RENESAS TECHNICAL UPDATE

Product Category	MPU & MCU		Document No.	TN-16C-A224A/E	Rev.	1.00
Title	Errata to R32C/117 Group User's Manual: Hardware		Information Category	Technical Notification		
Applicable Product	R32C/117 Group	Lot No.	Reference Document	R32C/117 Group User's Manual: Hardware Rev. 1.10 (REJ09B0533-0110)

This document describes corrections to the R32C/117 Group User's Manual: Hardware, Rev. 1.10. The corrections are indicated in red in the list below.

Figure 8.1 Clock Generation Circuitry

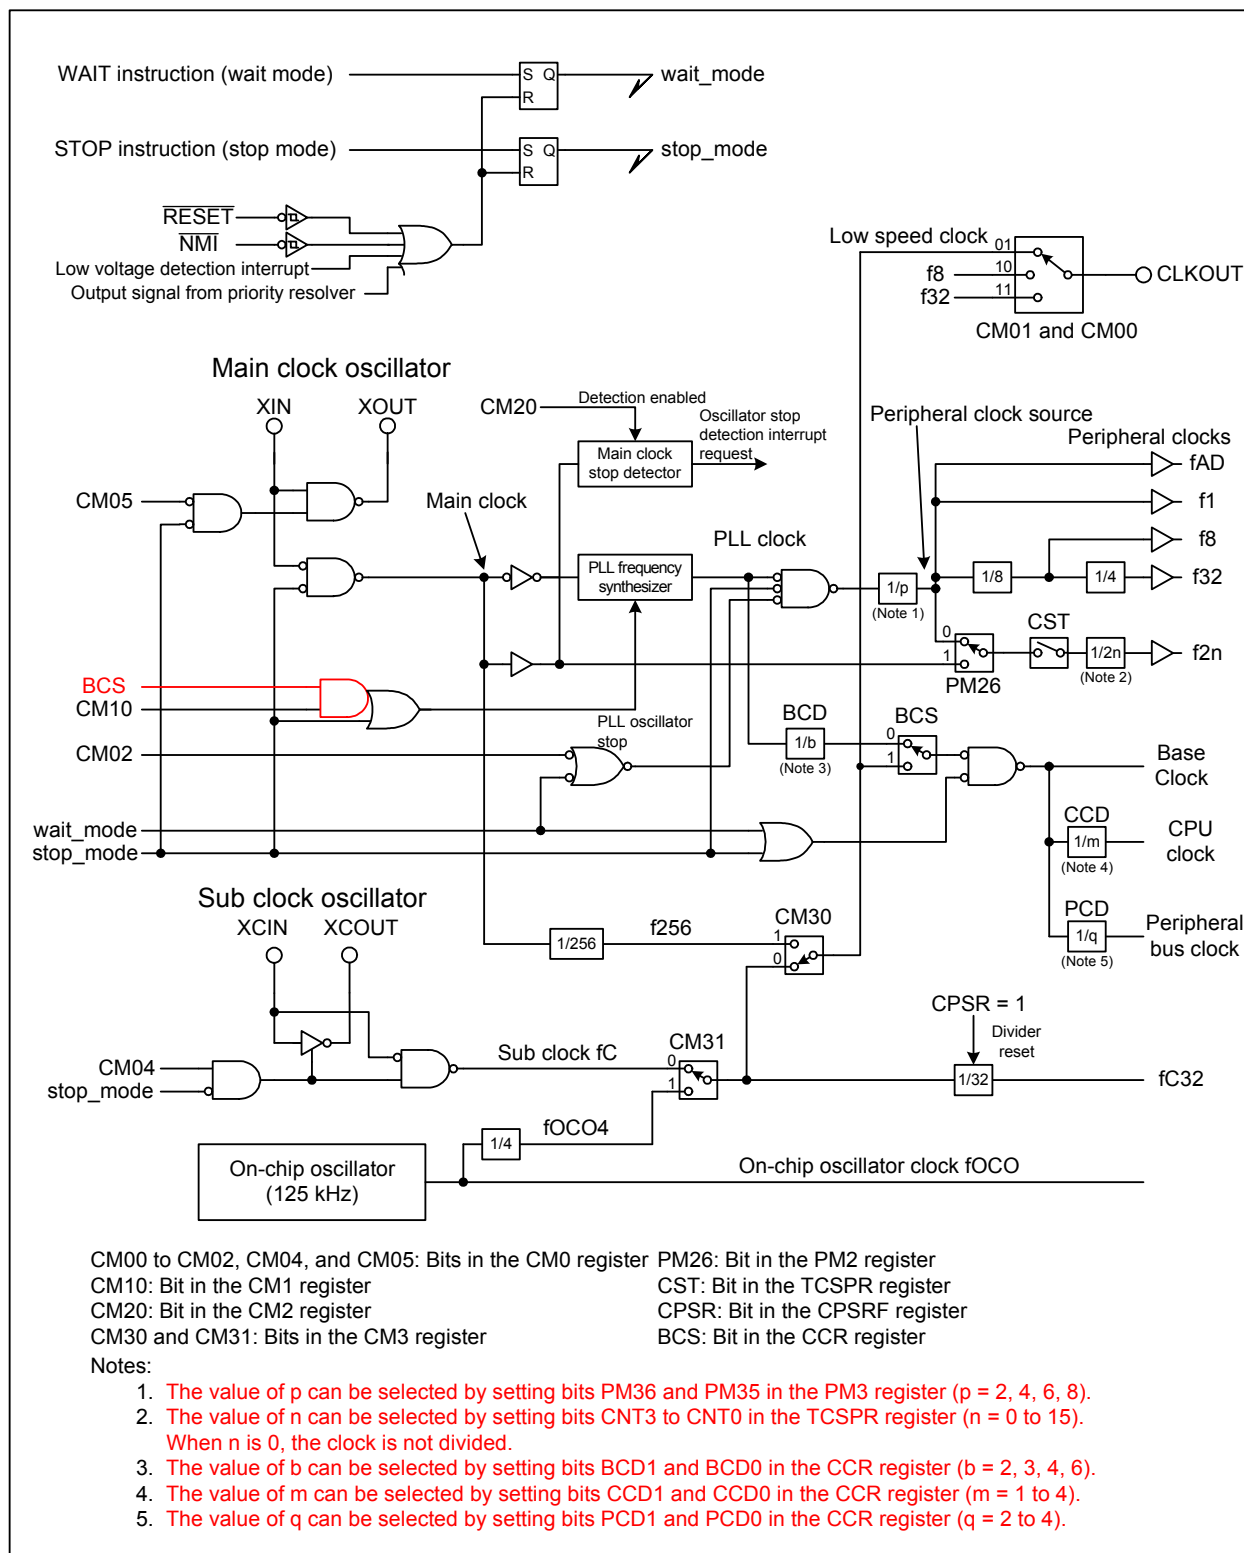
•Page 83 of 604, Figure 8.1 is corrected as follows:

Figure 21.1 CRC Calculator Block Diagram

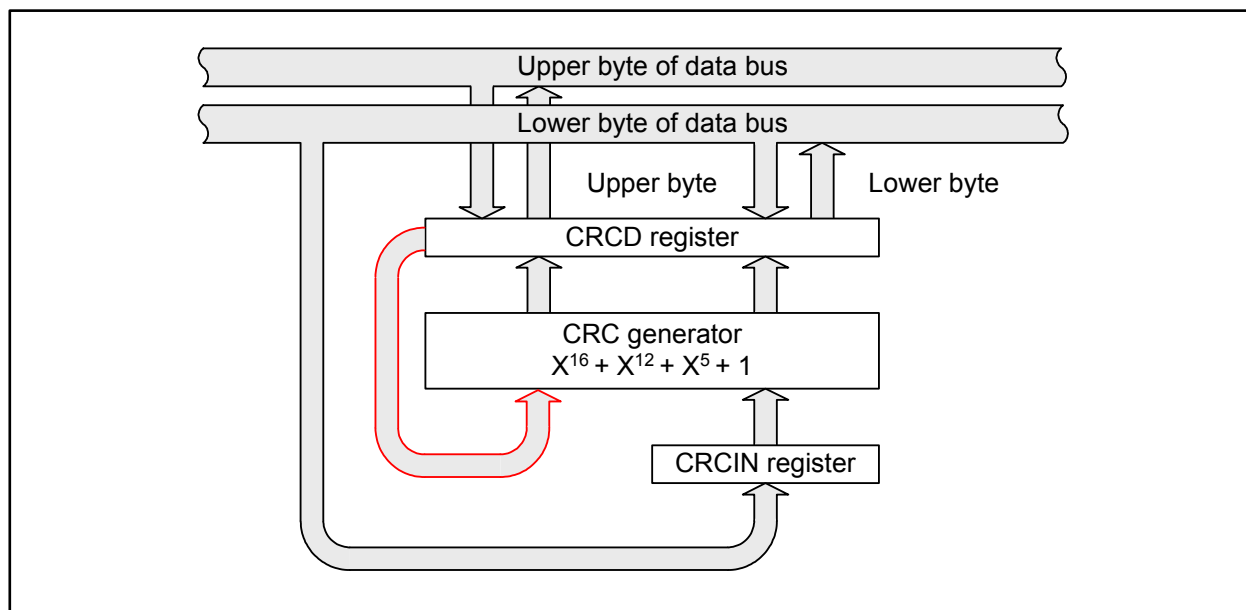
- Page 322 of 604, Figure 21.1 is corrected as follows:

Figure 26.1 Typical I/O Pin Block Diagram (i = 0 to 15; j = 0 to 7)

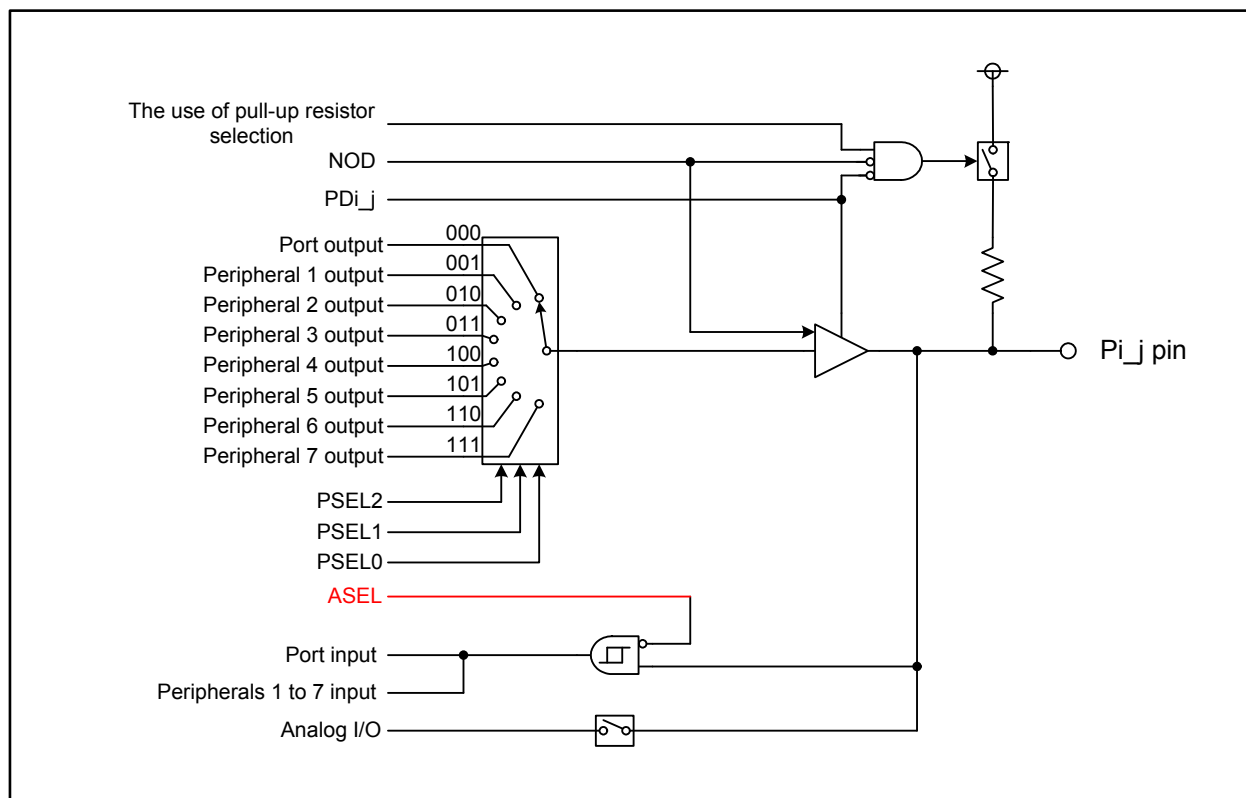
- Page 476 of 604, Figure 26.1 is corrected as follows (refer to TN-16C-A200A/E):
